Service Bulletin

Bulletin No.: 17-NA-357

Subject: Noise or Malfunction of Trim Door on Broken Quarter Upper Trim Panel, Possible Convertible Top Inoperative

4889569

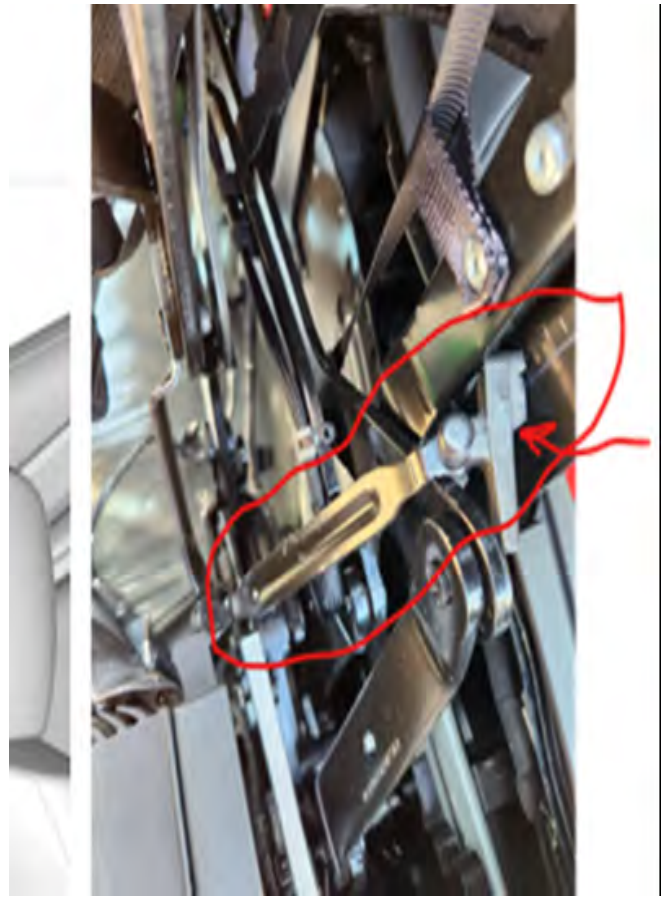
Note: For vehicles built prior to February 14, 2017, it will also be necessary to replace the window regulator in addition to the quarter upper trim panel to accommodate the added 3rd clip design.

Important: Under no circumstances should the 3rd clip be removed from the quarter upper trim panel.

- **For vehicles-built February 14, 2017 and after,** replace the quarter upper trim panel (1) AND the rear side rail link assembly at the same time. Refer to *Quarter Upper Trim Panel Replacement* and *Folding Top Rear Side Rail Link Trim Cover Replacement* in SI.

6484483

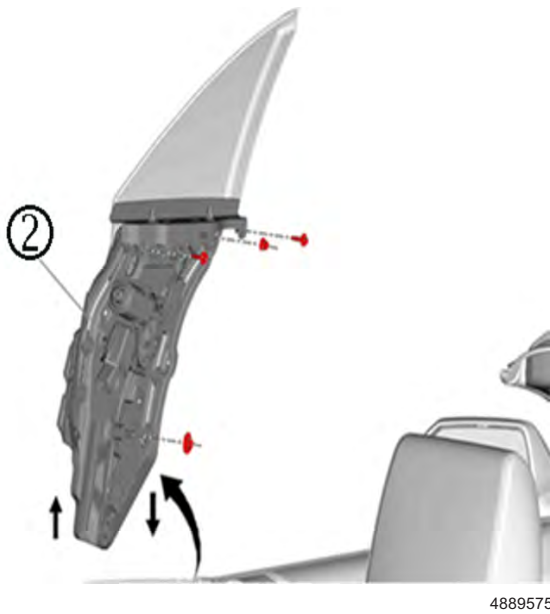
- For vehicles built prior to February 14, 2017, replace the quarter upper trim panel AND the quarter window regulator (2). Refer to *Quarter Window Regulator Replacement* in SI.
